SUBJECT: Guide for Paving Shoulders Under Bridges – Standard

Drawings Revision and Design Manual Changes

This is to advise you of a recent revision to the 2012 Roadway Standard Drawings. The revision affects Standard Drawings 610.01, 610.02, and 610.03 – Guide for Paving Shoulders under Bridges Method I, Method II, and Method III, respectively. It also includes the addition of a new standard drawing – Guide for Paving Shoulders under Bridges Method IV.

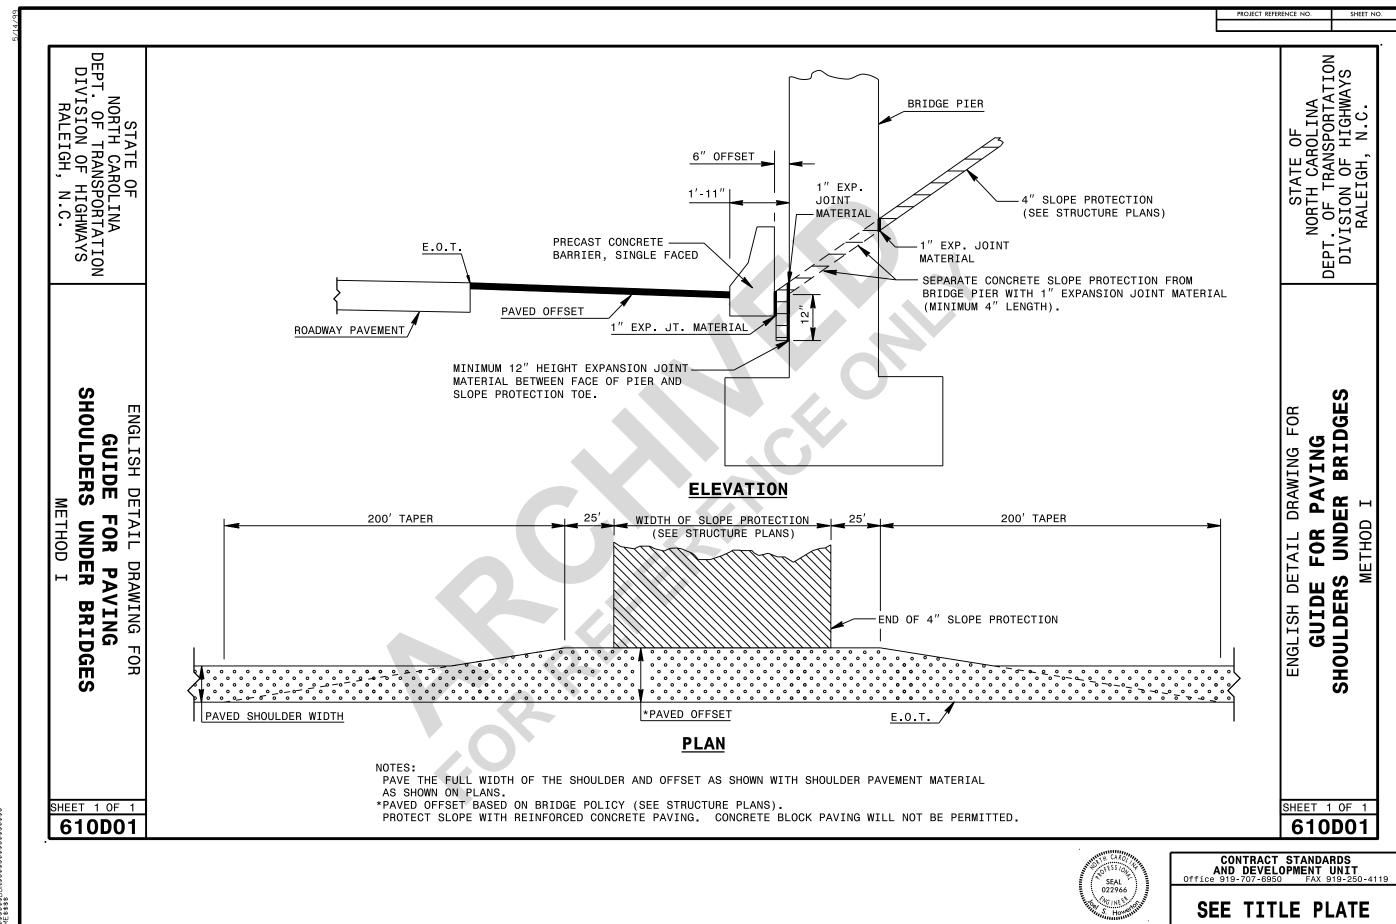
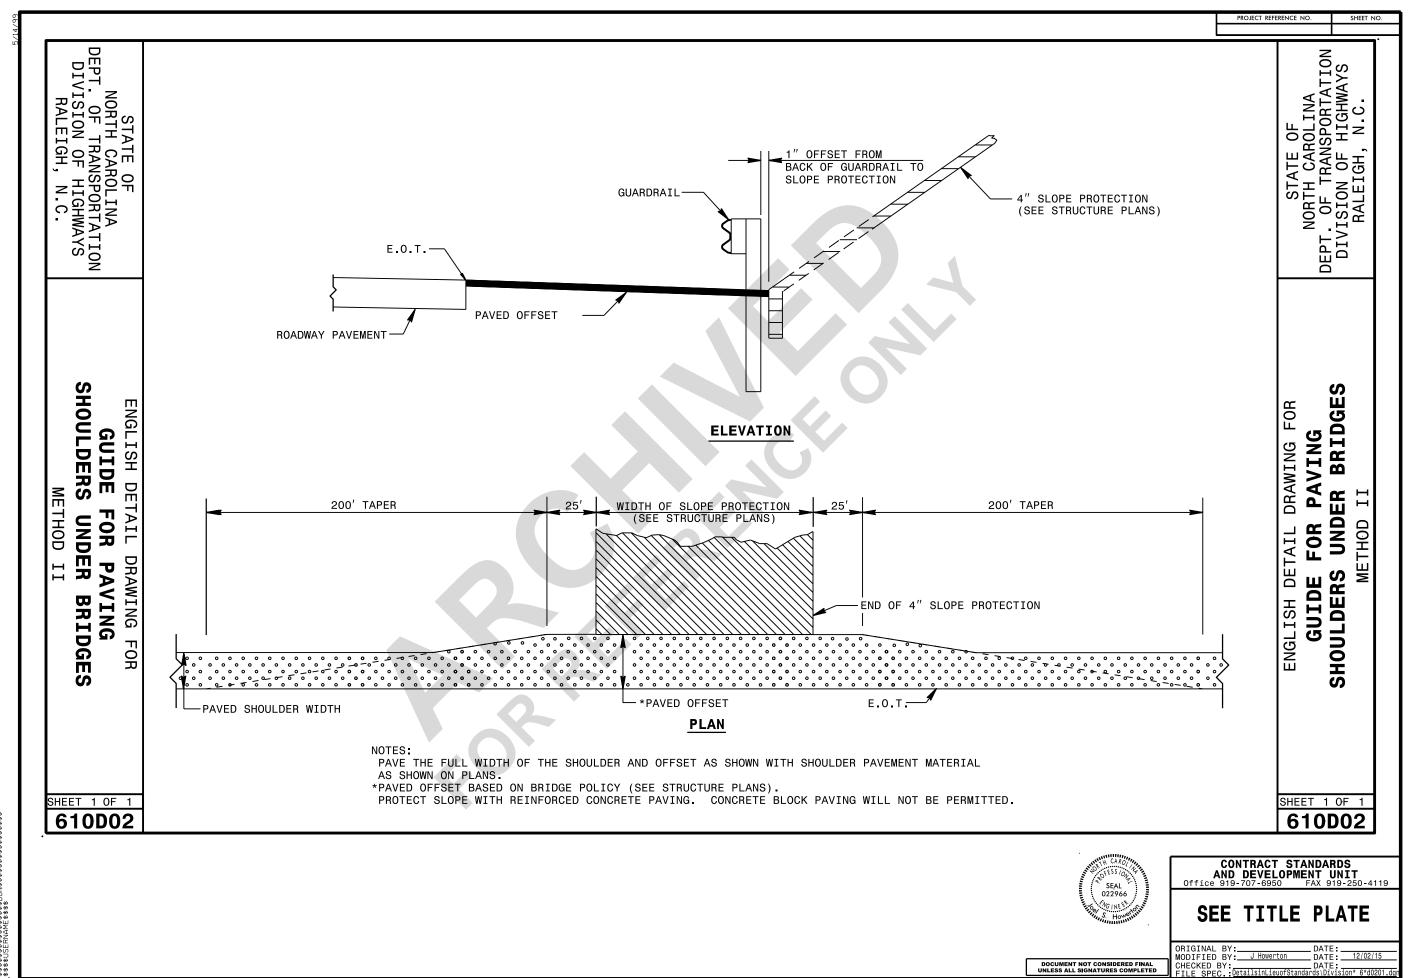
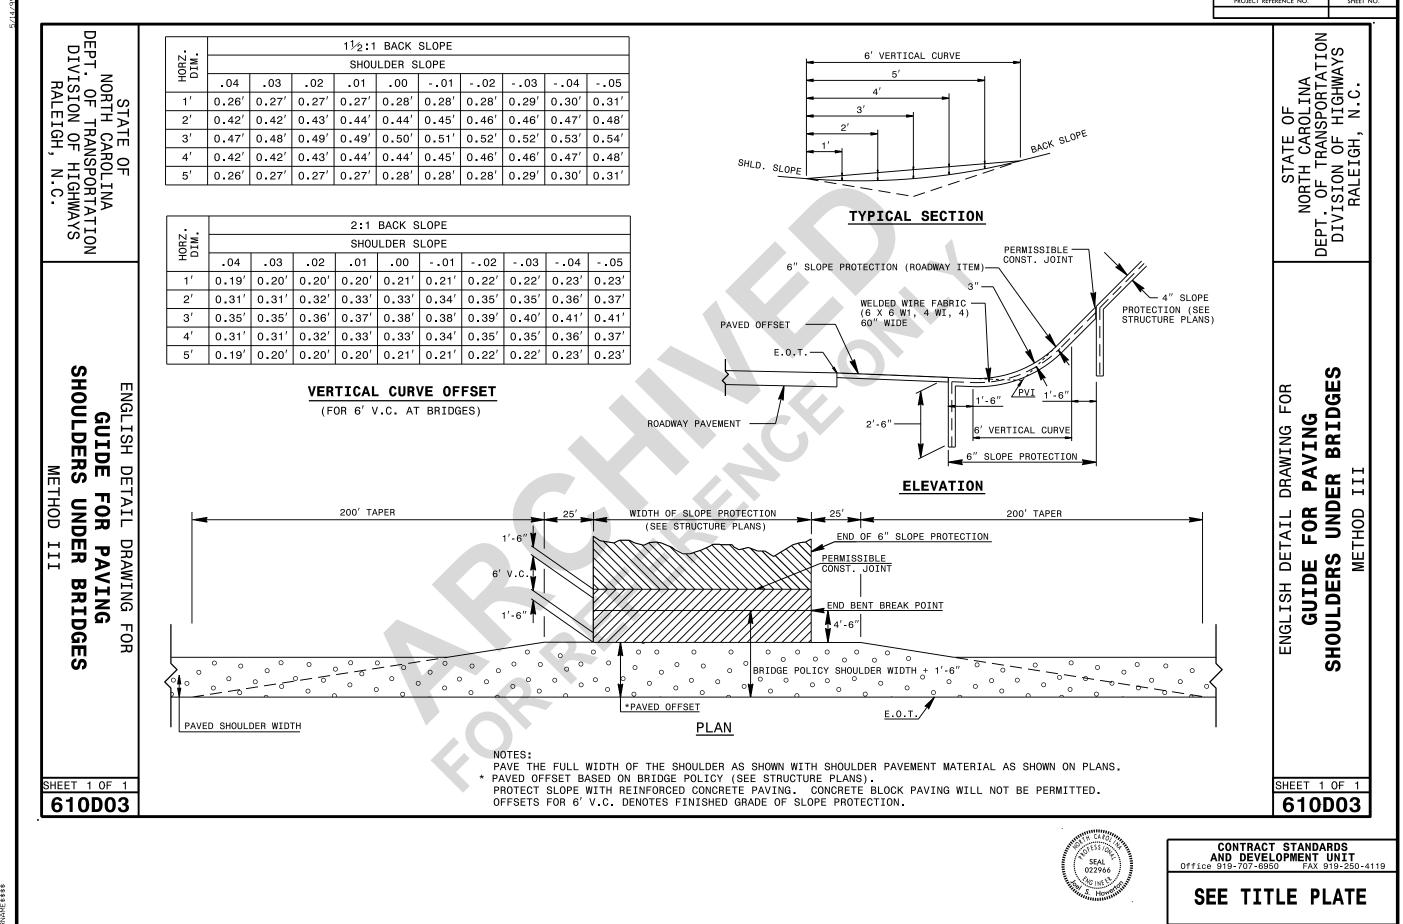
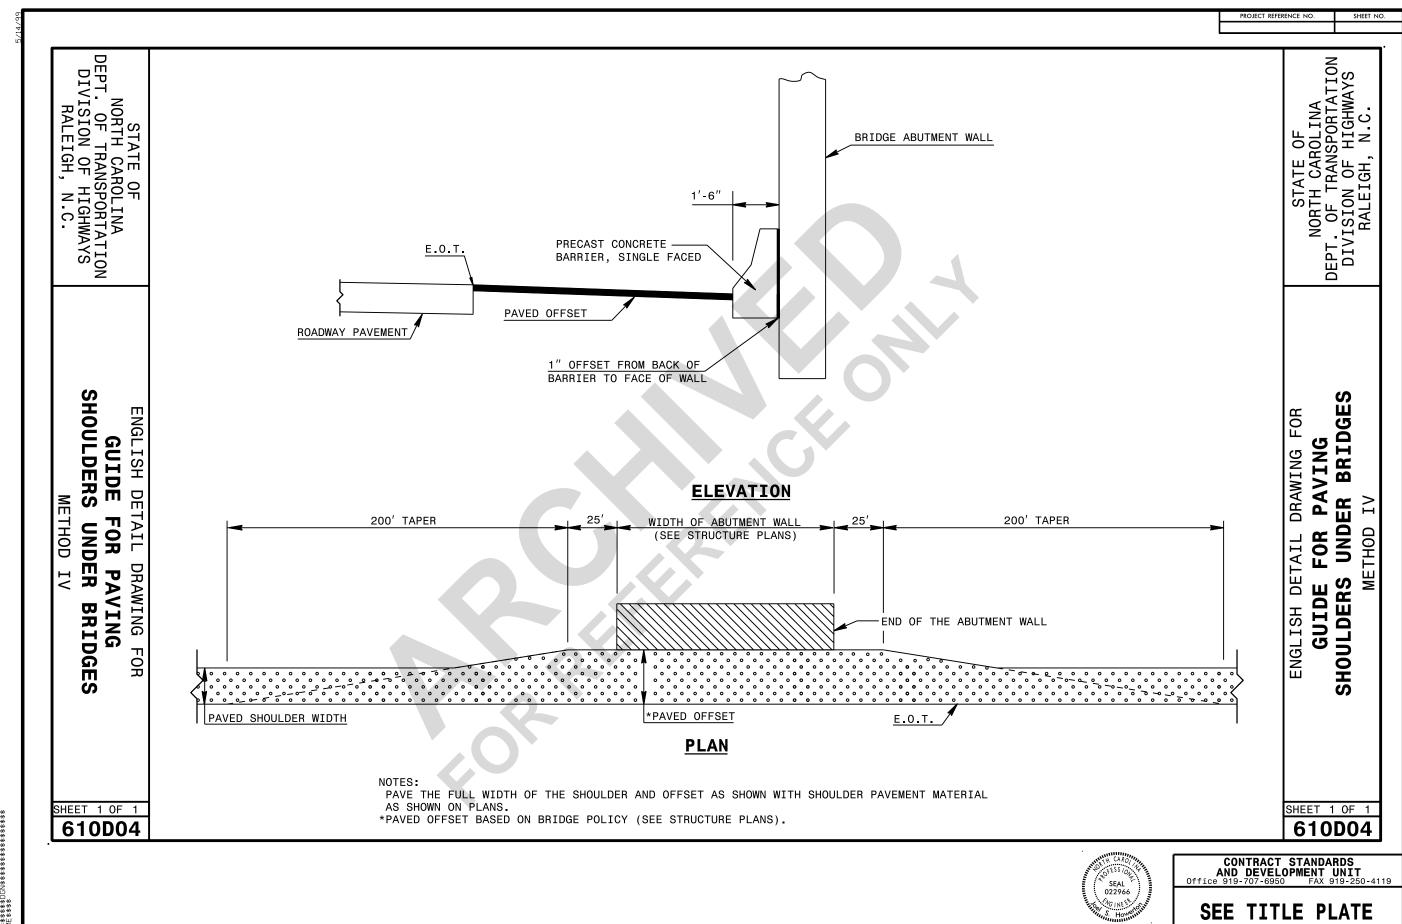
New special details (610D01, 610D02, 610D03, 610D04) which address the revisions made to Standard Drawings are now available under <u>Connect NCDOT – Resources – Specifications – 2012 Roadway Standard Drawings - 2012 Revisions to Roadway Standard Drawings</u>. Please use these special details in lieu of Standard Drawings effective with the March 2016 Let (December 8, 2015 turn-in).

FIGURE 1R 6-1

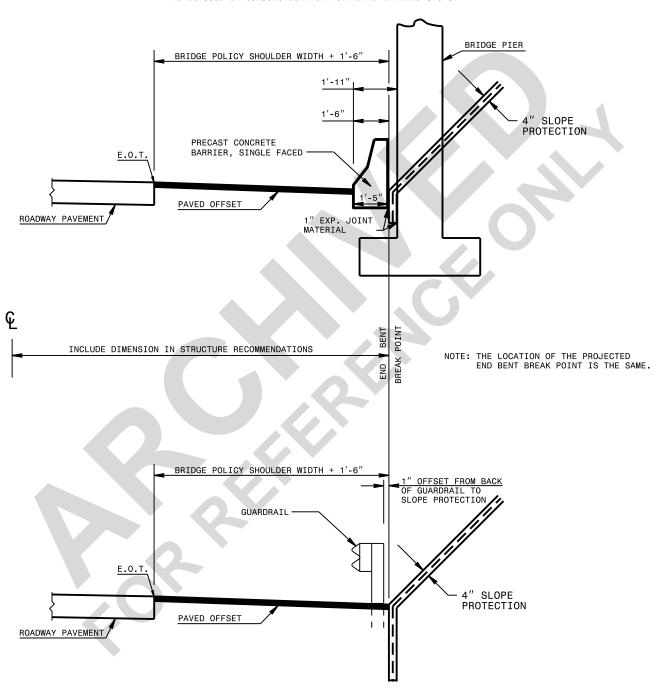
This — paragraph was added with the 12-02-15 revision

The paved offset will vary based on the proposed end bent shoulder treatment under the bridge (bridge pier, guardrail, 6" slope protection, abutment wall). See 6-1, Figures F-1R and F-1S for details to be used with the Roadway Standard Drawings for clarification. The break point for the end bent slope is the same in each case. This will result in a consistent bridge length regardless of the end bent shoulder treatment.
